**SECTION 00 90 04
BIDDING AND CONTRACT REQUIREMENTS
ADDENDUM NUMBER 4**

Issued: October 12, 2023

Re: ADDENDUM NUMBER (4) TO THE BIDDING DOCUMENTS FOR

**McHenry County College
University Center at MCC**
Architect's Project Number: 22-050

SHEET NUMBER:
E1.10

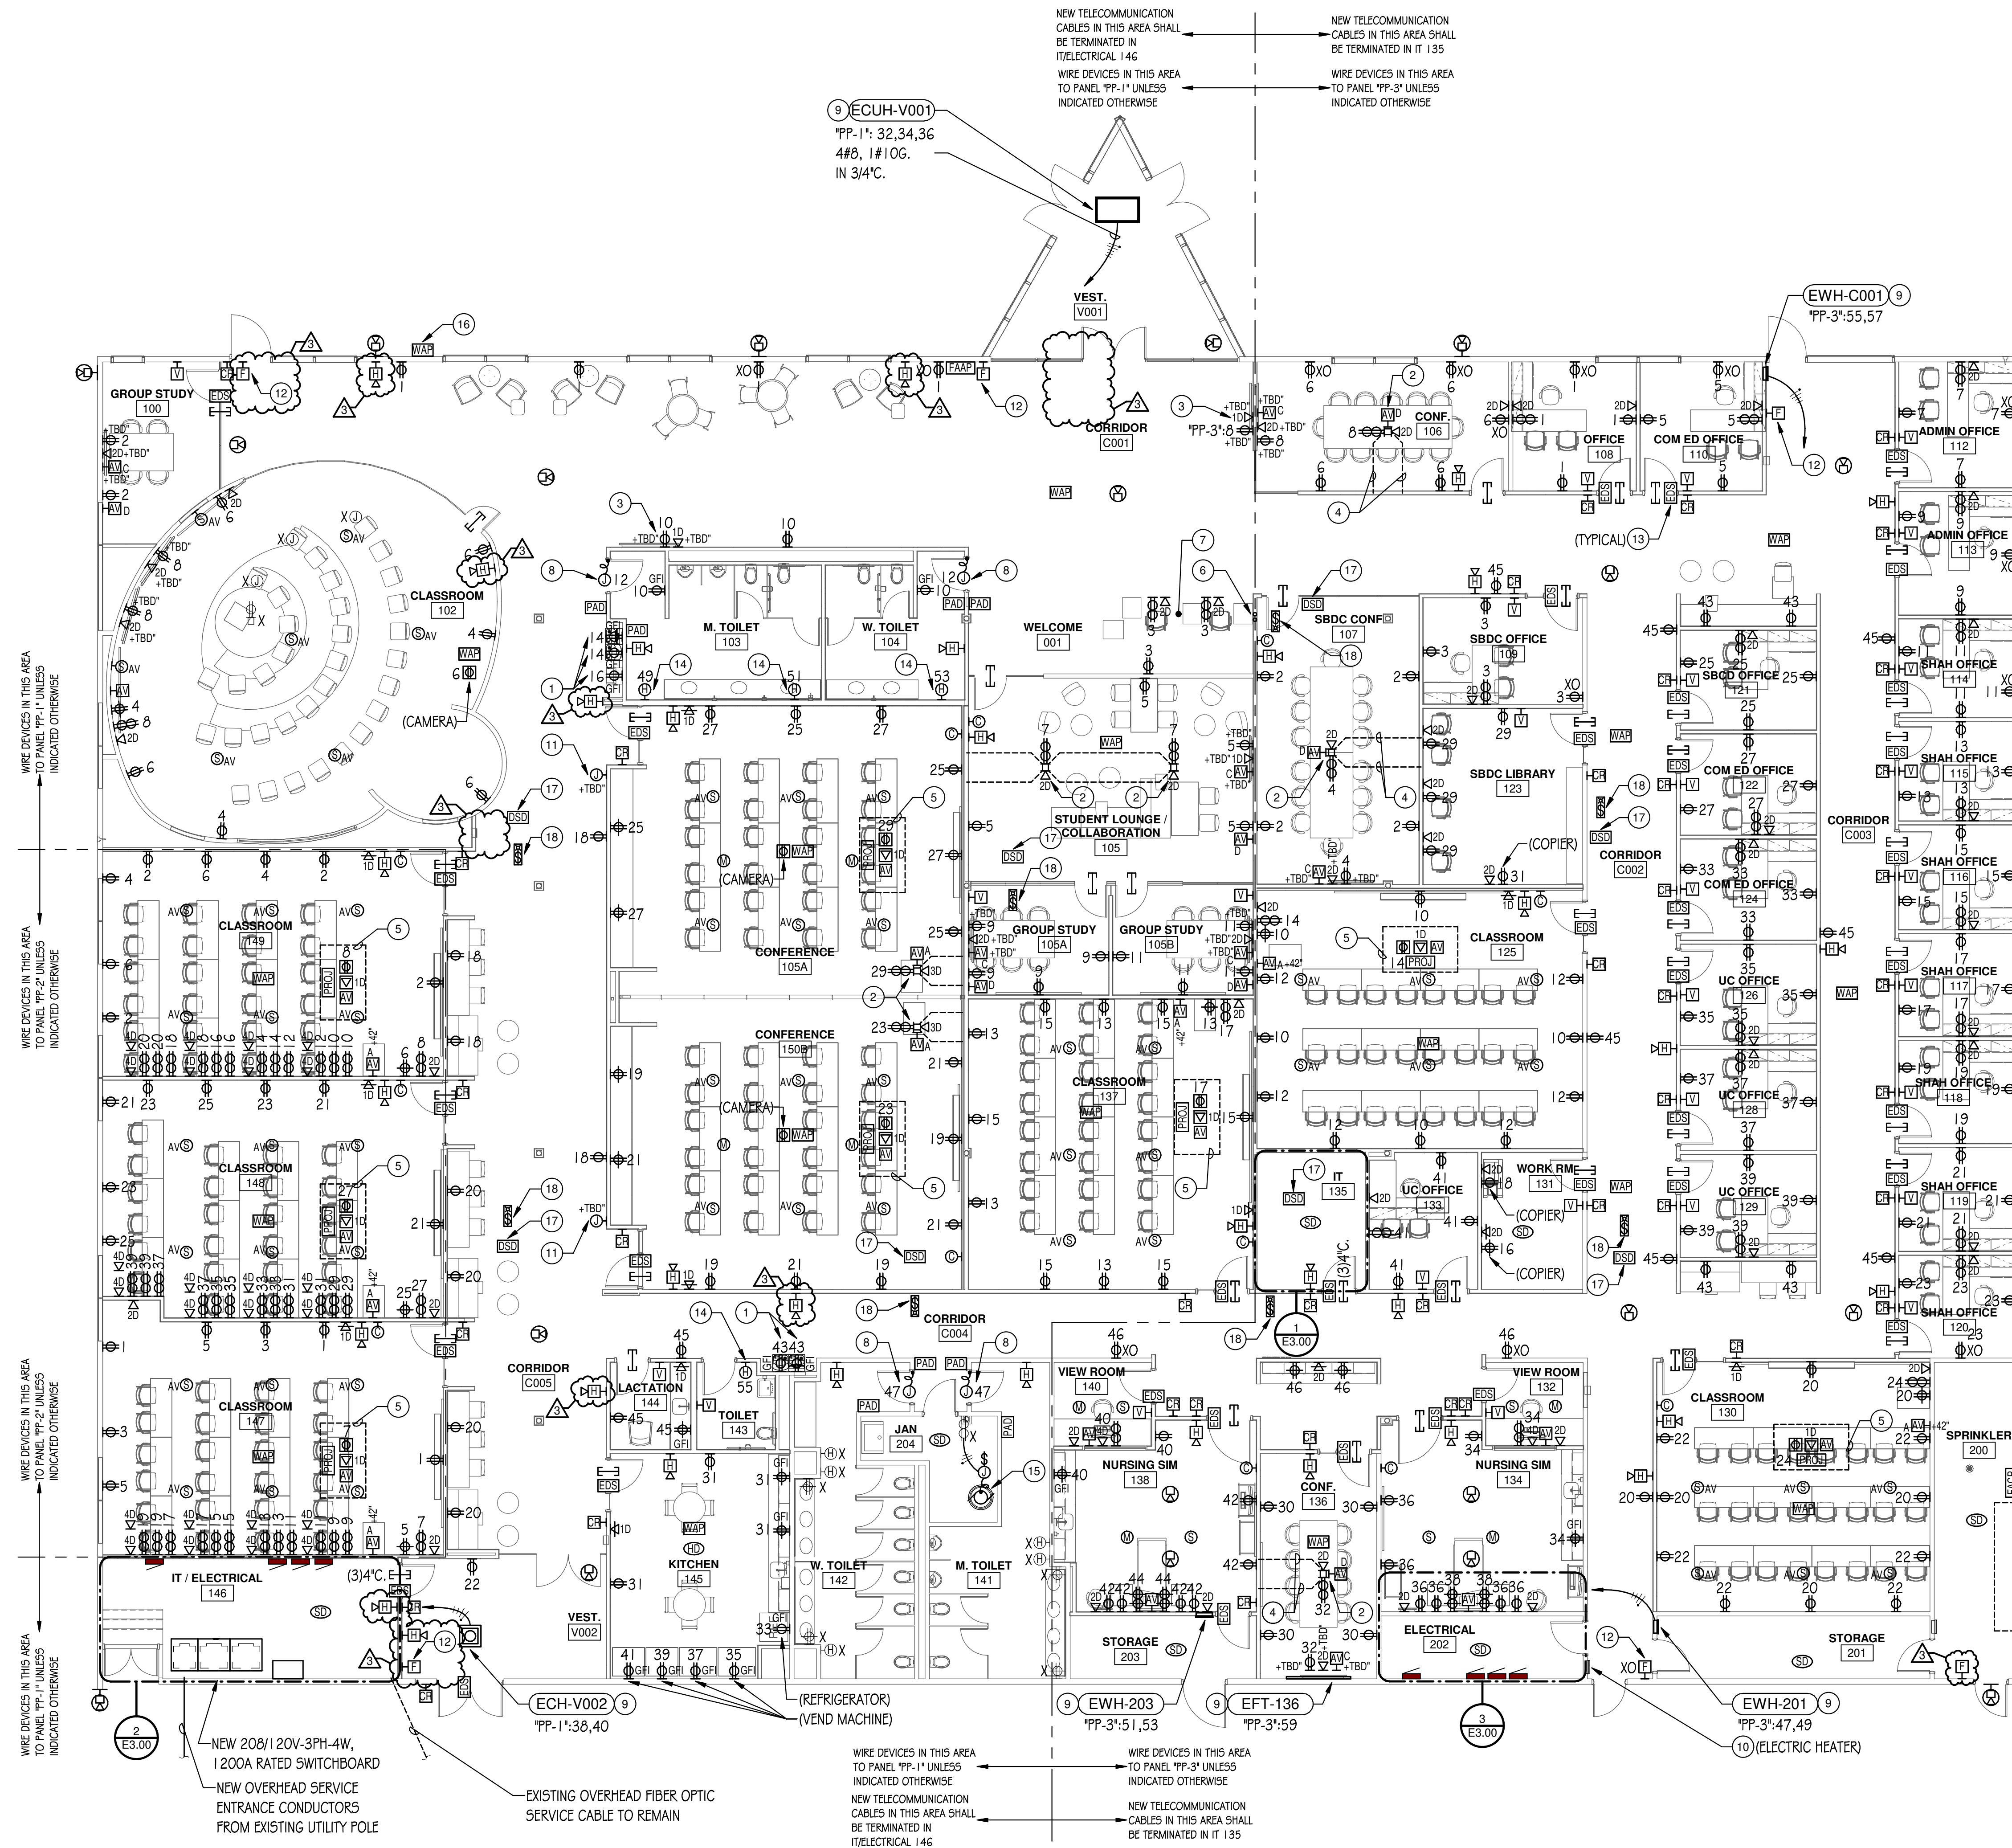
1. E1.10
 - A. **ADD** fire alarm devices in Corridor C001, Corridor C004, Corridor C005, Classroom 102, Sprinkler 200, Vestibule V002, IT/Electrical 146.
 - B. **DELETE** junction box outside Classroom 102.
 - C. **REVISE** drawing note #11.
 - D. **DELETE** door operators and associated power requirements at door V001.
2. E2.10
 - A. **ADD** remote emergency heads outside Vestibule V001.
 - B. **REVISE** emergency lighting type in Vestibule V001.
3. E5.00
 - A. **REVISE** description for clocks to read:
"BATTERY OPERATED CLOCK, CONNECTED WIRELESSLY TO A MASTER CLOCK SYSTEM."
4. E6.00
 - A. **ADD** alternate manufacturers for luminaire types "F11", "F12", "F13", "F15".
 - B. **ADD** note 5 to luminaire types "F16A", "F16B", "16C", "F16D", "F16E", "F16F".

TYPICAL NETWORK RACK DETAIL
NO SCALE

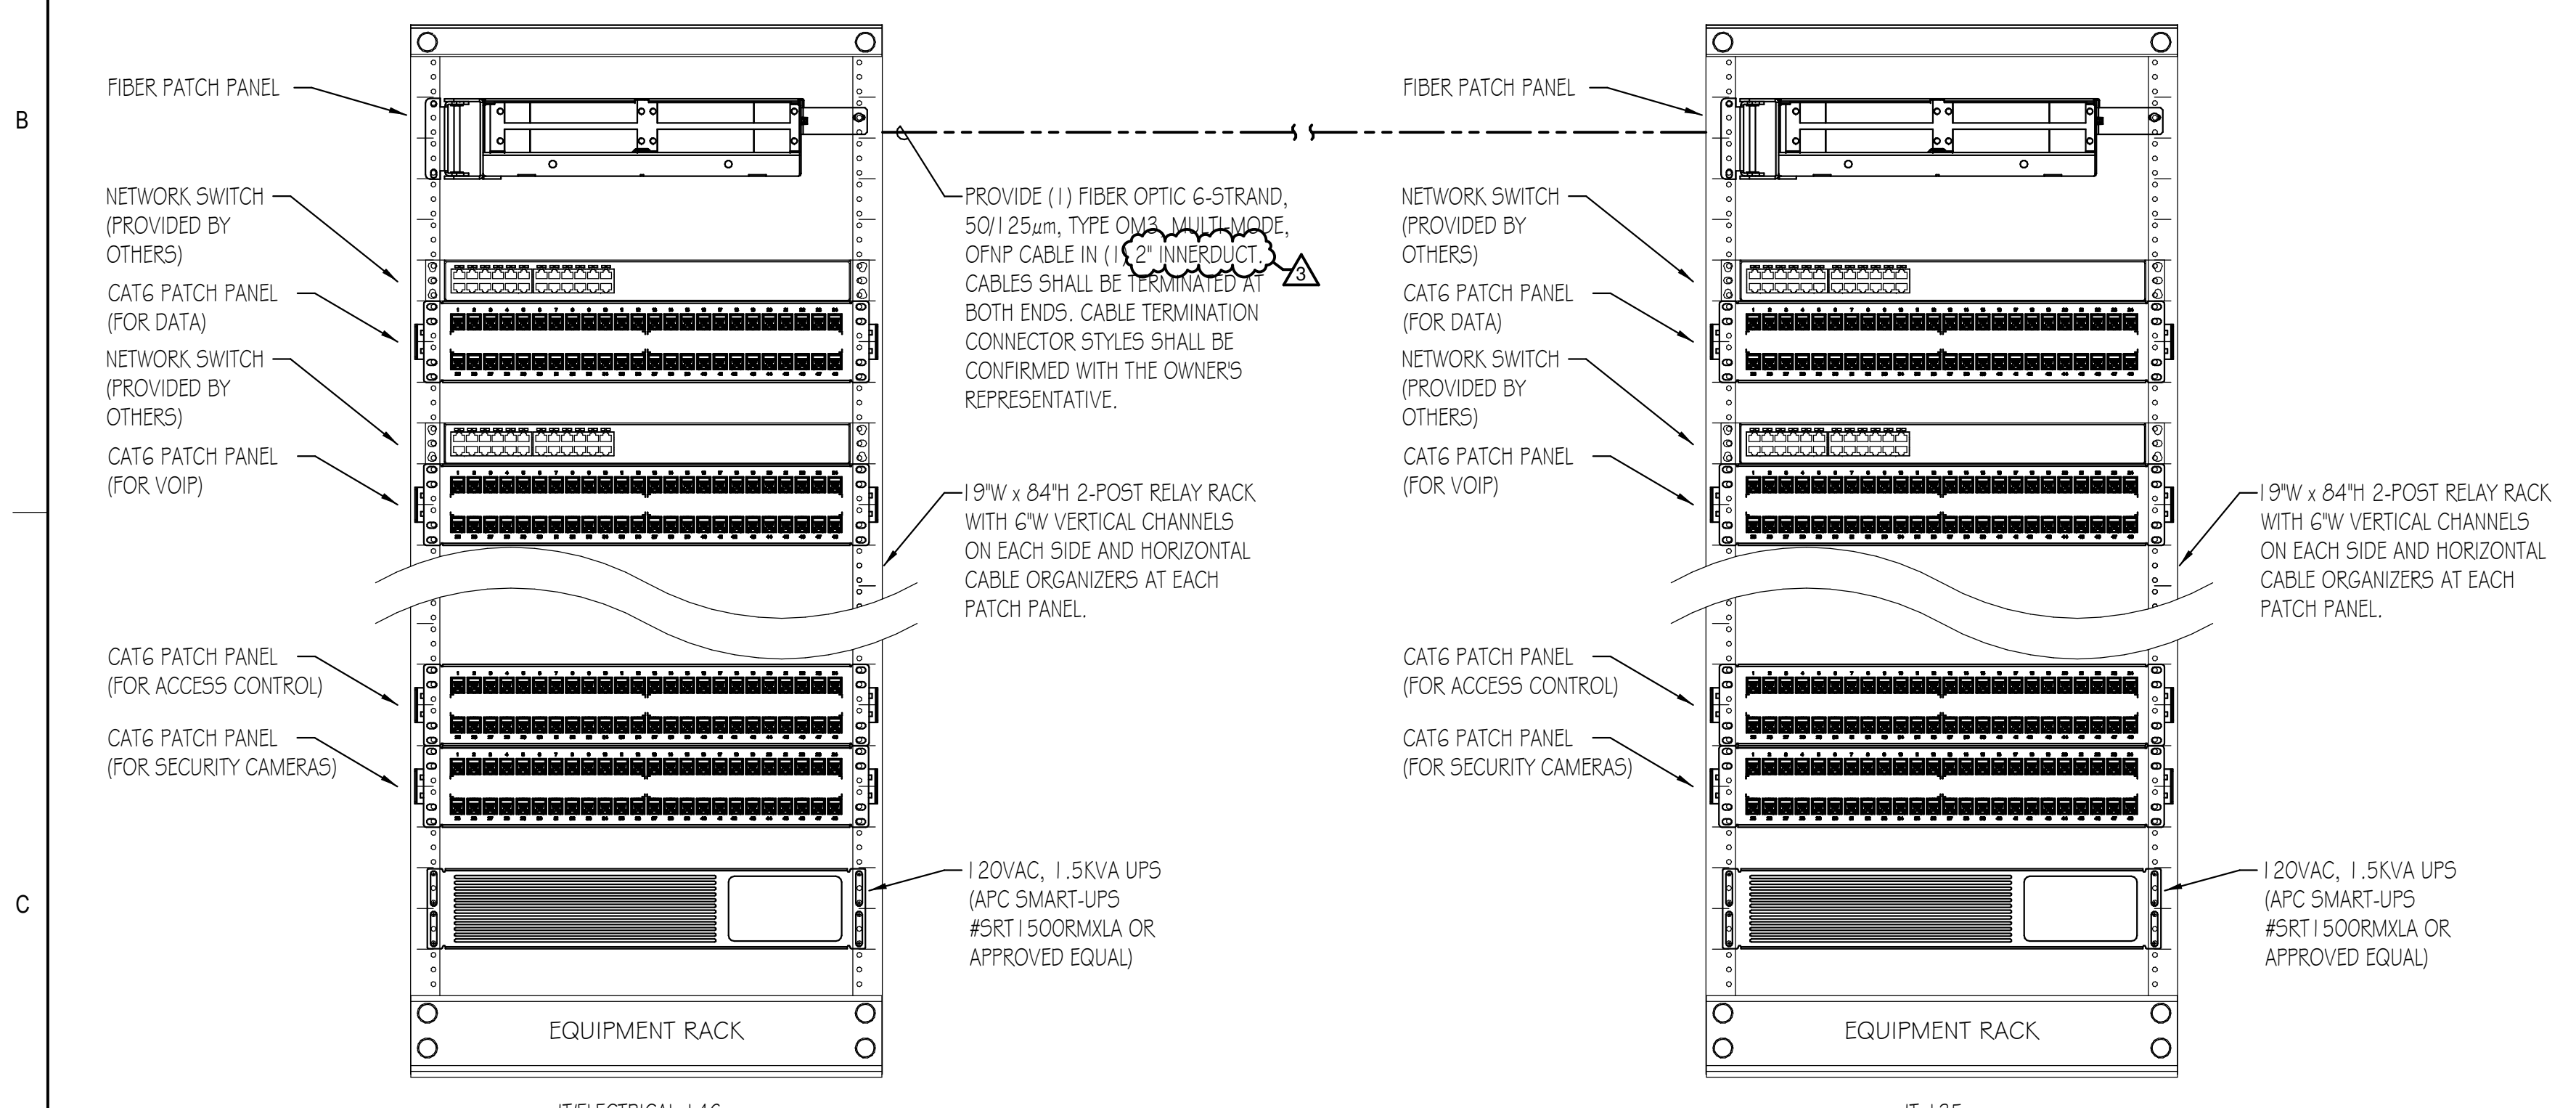
- C. **ADD** note #5 to 'LUMINAIRE SCHEDULE'.
- 5. E7.10
 - A. **REVISE** 'TYPICAL NETWORK RACK DETAIL' to indicate 2" innerduct for routing of fiber optic backbone cable.
- 6. E7.30
 - A. **REVISE** 'A/V RECEIVER OUTLET DETAIL'.
 - B. **REVISE** 'A/V TRANSMITTER OUTLET DETAIL'.
 - C. **ADD** 'A/V OUTLET DETAIL'.
